Report to Heritage Wilmot and Castle Kilbride Advisory Committee

Report No: HCAC 12-24

Subject: Oxford Waterloo Road Bridge 37/B

OXFORD-WATERLOO ROAD
TURNING CIRCLE
OPTION 1

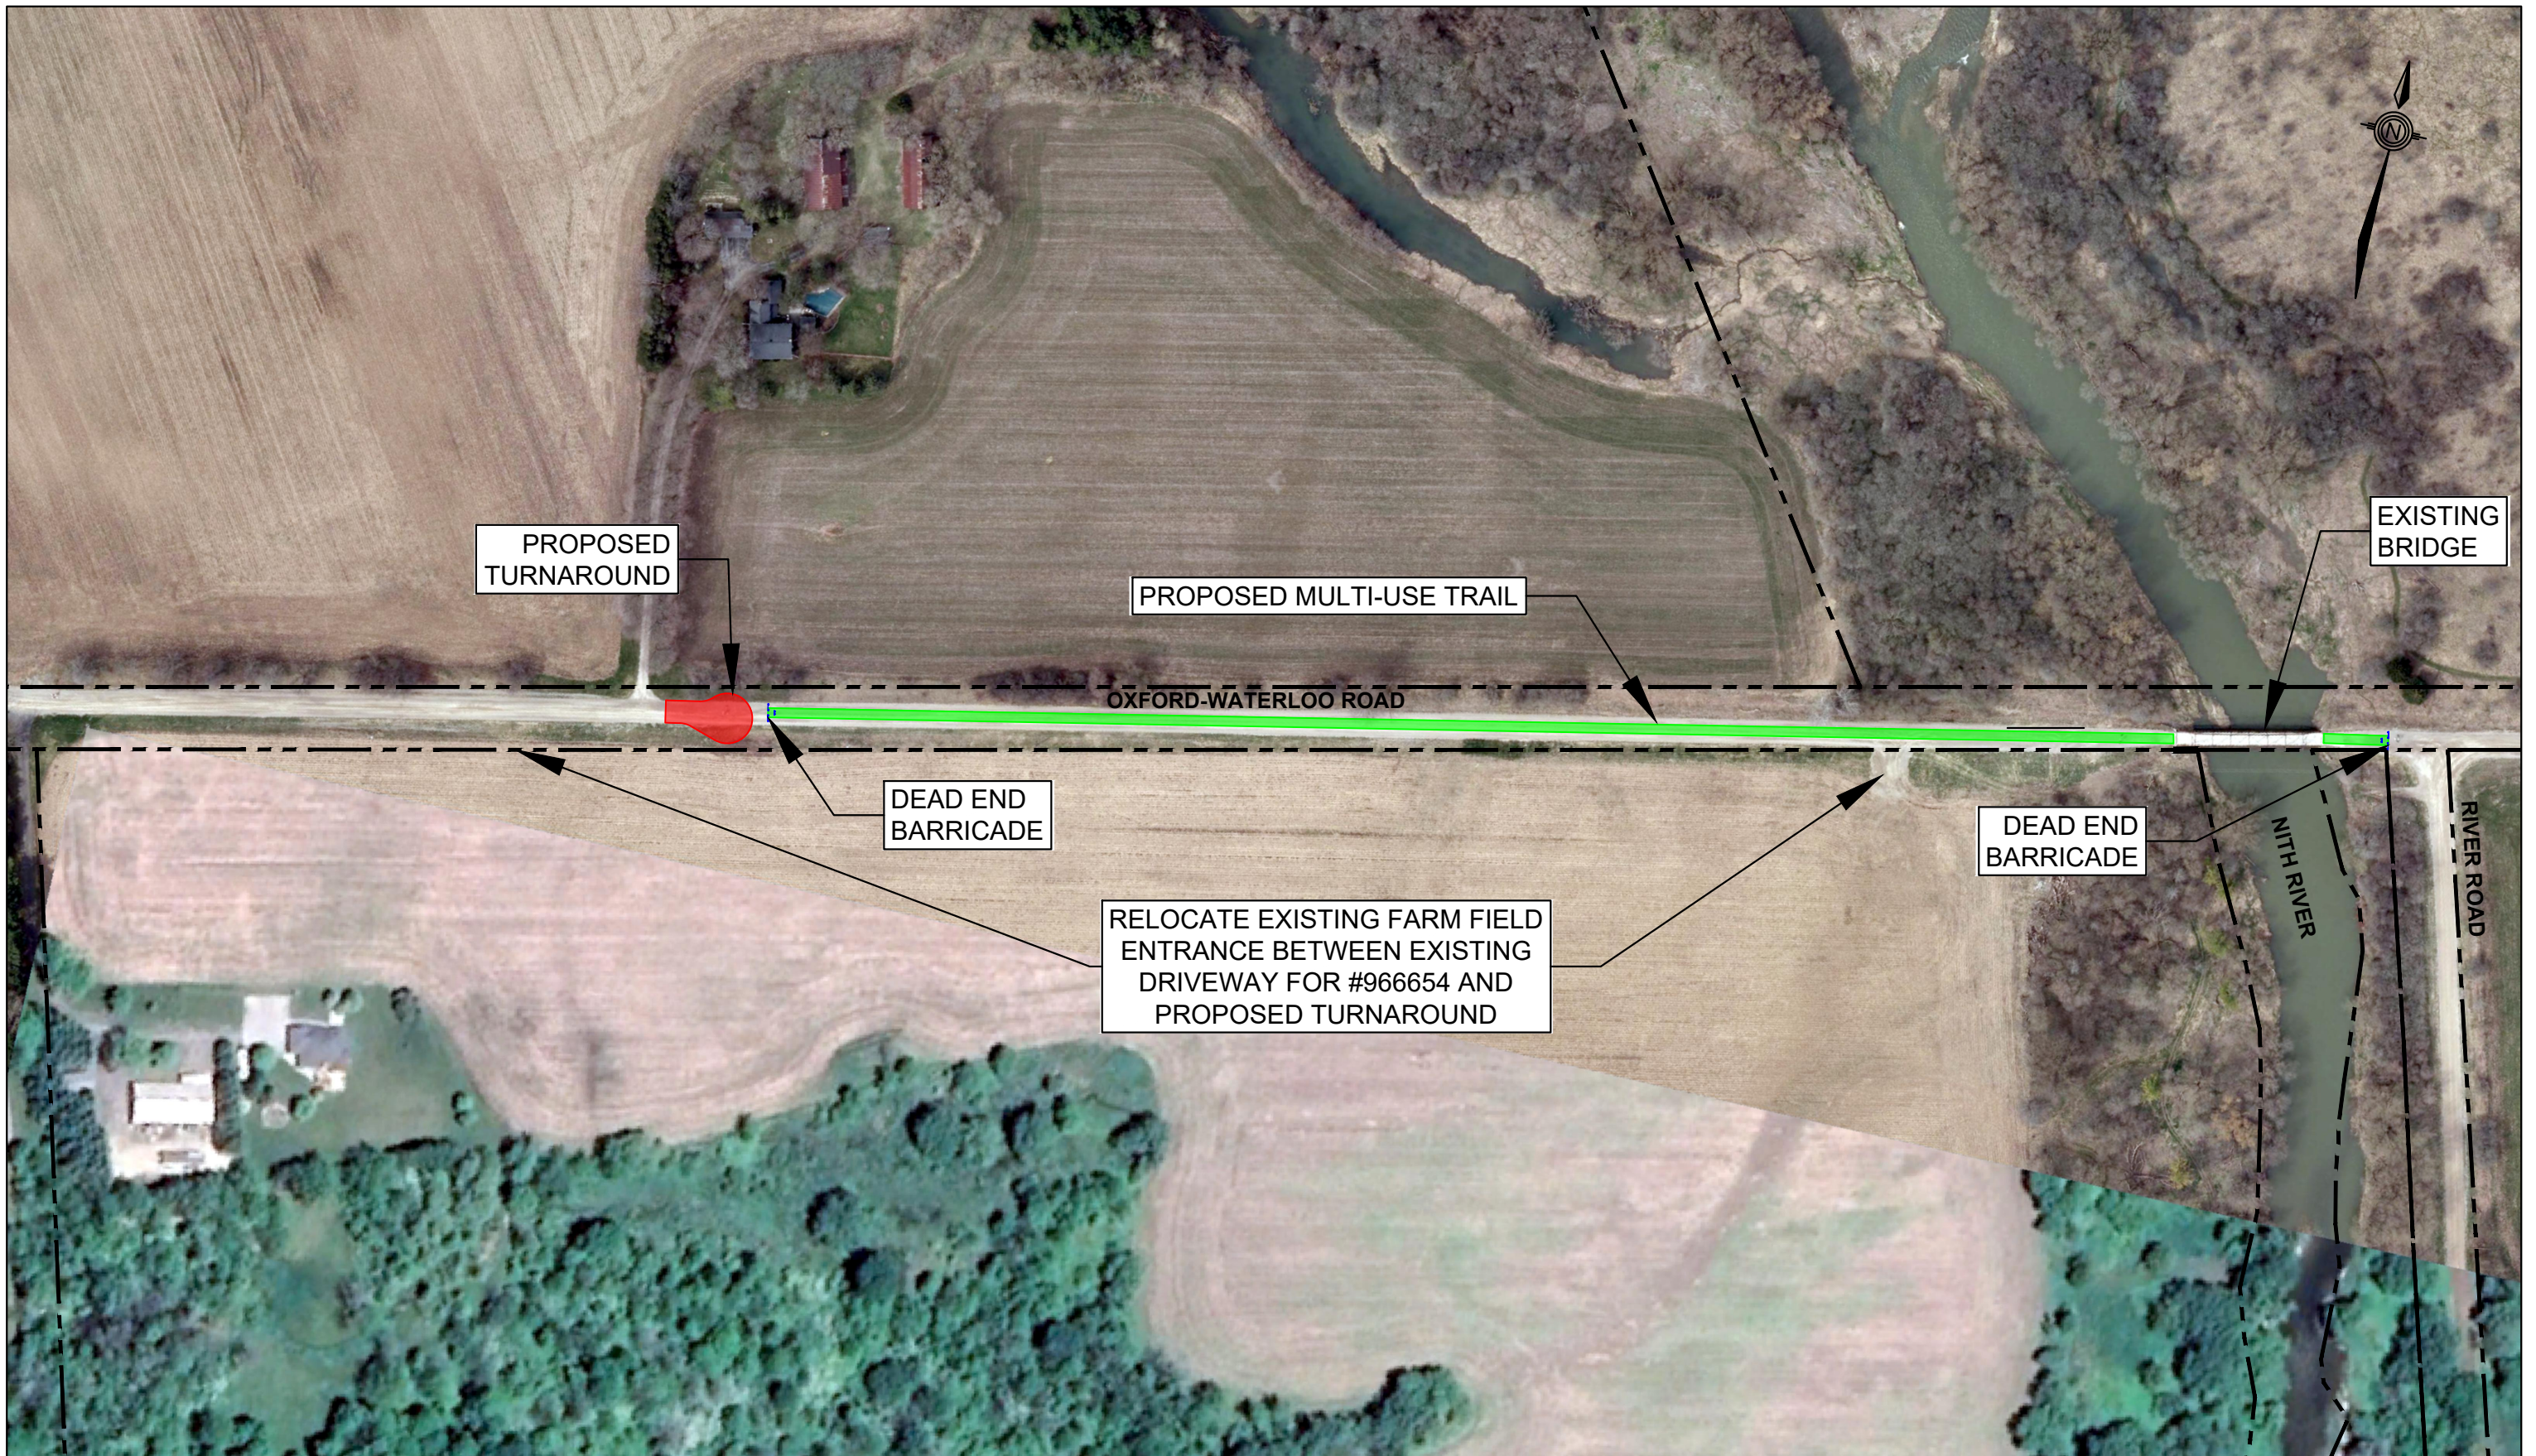
1. A multi-use trail beginning east of the existing field entrance to property 966654 Oxford Waterloo Road and ending on the east side of the bridge, terminating before the intersection of River Road. A traffic turnaround for road maintenance purposes will be established on the west side of the bridge, just west of the start of the proposed trail and east of the field entrance to the adjacent property.
